**Environmental  
Protection Agency**

July 11, 2011

RE: WAYNE COUNTY  
CITY OF RITTMAN  
NEW RITTMAN HIGH/MIDDLE SCHOOL  
CONSTRUCTION STORM WATER

Figure 4 – Sediment is being tracked onto the paved parking lot.

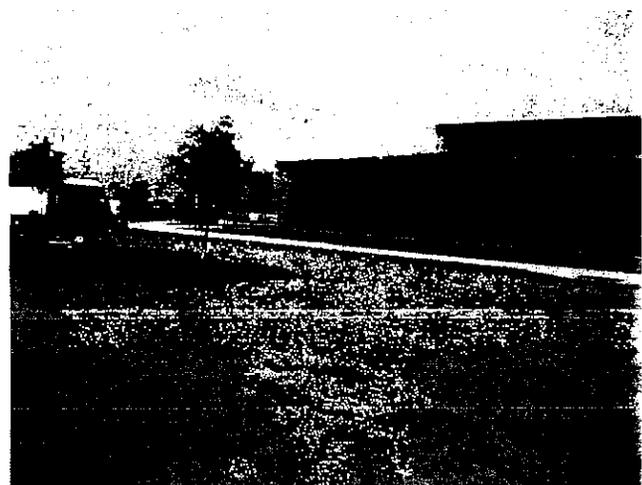
4. Sediment is currently being tracked onto the paved parking lot (Figure 4). Please clean the parking lot regularly to prevent this sediment from being washed into the storm drains.
